**PLANNED UNIT DEVELOPMENT
STAFF REPORT****Date: April 5, 2007****DEVELOPMENT NAME**

Spectronics Addition

Montlimar Office Park

SITE PLAN

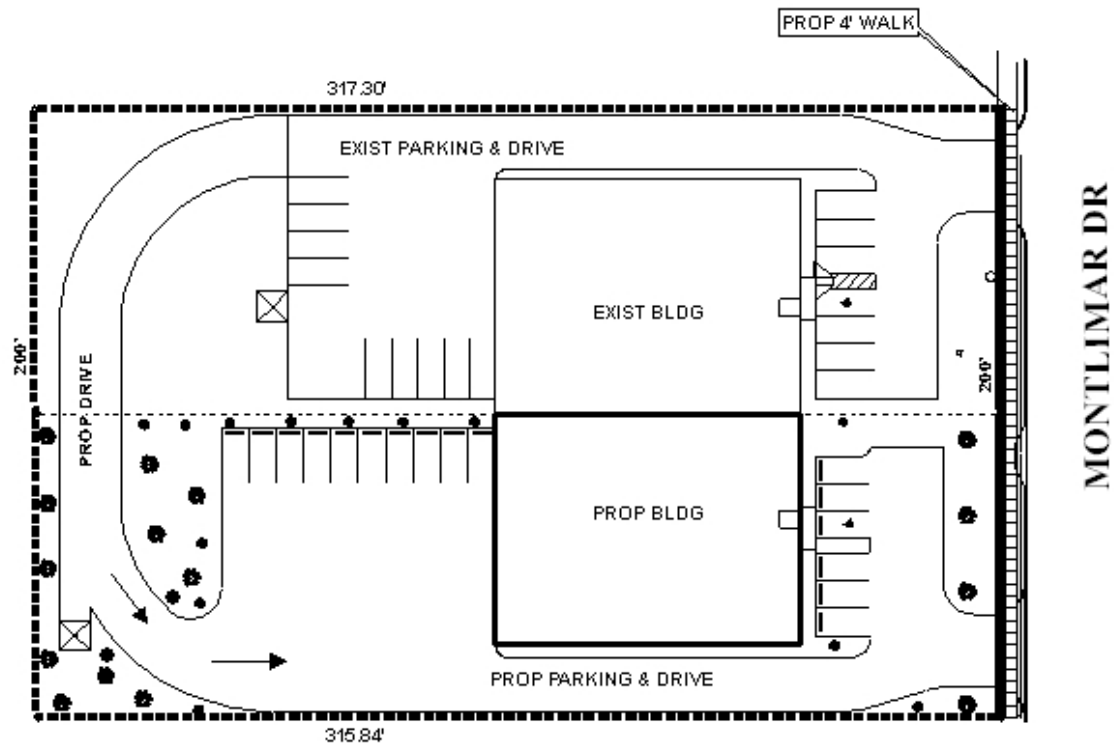
The PUD aspect of this application is the proposed driveway linking the two sites at the rear. The existing building has an 18-foot wide driveway linking a parking area in front of the building with a parking area behind the building. The width of the driveway does not meet the minimum standards for two-way traffic. The applicant proposes that the new development provide a driveway of the same width, and that the two rear parking areas be linked by a 20-foot wide drive. As all proposed circulation will be inadequate for two-way circulation, the site plan should be revised to depict one-way circulation to and through the rear portion of site.

It appears that the site has adequate room to provide a double-loaded 90 degree parking area behind the building, and this arrangement may result in more parking with a reduced paving area. Also, the site might benefit from allowing circulation across the front parking areas, although the existing parking area at the front of the existing building may not have adequate width to support this.

As the applicant is requesting a PUD, information regarding the landscaping of the existing site should be provided. If the existing site is not in conformance with the requirements of the Zoning Ordinance, additional trees and landscape area must be provided in order to bring the site into compliance. The site plan should be revised to provide calculations for the existing portion of the site.

The applicant should also revise the site plan to include information regarding the required parking for the existing development. The applicant should differentiate between the retail square footage and the warehouse area, and the number of warehouse employees for the existing development.

The site abuts residential development to the West. A 10-foot buffer depicted on the site plan should be augmented with the depiction and notation of a 6-foot high wooden privacy fence. A note should also be placed on the site plan stating that all lighting of the site and the parking area will be in compliance with the requirements of Sections 64-4.A.2. and 64-6.A.3.c. of the Zoning Ordinance; specifically lighting must not shine directly into adjacent residential properties or into traffic, and parking areas must be illuminated during their operation at night, if applicable.

The proposed building and parking area will increase the impervious area on the property, thus on-site stormwater detention may be required: the general detention area should be depicted on the site plan, if required.

The revised site plan addresses all of the requested items except # 6, which should be placed as a note on the plat.

Regarding item #3, it is recommended that the directional arrows be placed at the entry and exit locations near the front of each building and at the rear parking areas so that the one-way condition will be more clearly delineated for parking lot users.

Based on the revised site plan, the application is recommended for Approval, subject to the following conditions:

- 1) placement of a note on the site plan stating that all lighting of the site and the parking area will be in compliance with the requirements of Sections 64-4.A.2. and 64-6.A.3.c. of the Zoning Ordinance;

- 2) revision of the one-way arrows to be near the entry and exit locations for the drives leading to and from the rear parking areas;
- 3) full compliance with Engineering comments (*If using existing detention facility, verify the functionality and capacity and that the site was intended to tie to the existing pond. Must comply with all storm water and flood control ordinances. Any work performed in the right of way will require a right of way permit.*);
- 4) provision of one (1) copy of the revised site plan to the Planning Section of Urban Development prior to a request for land clearing or building permits; and
- 5) full compliance with all municipal codes and ordinances.
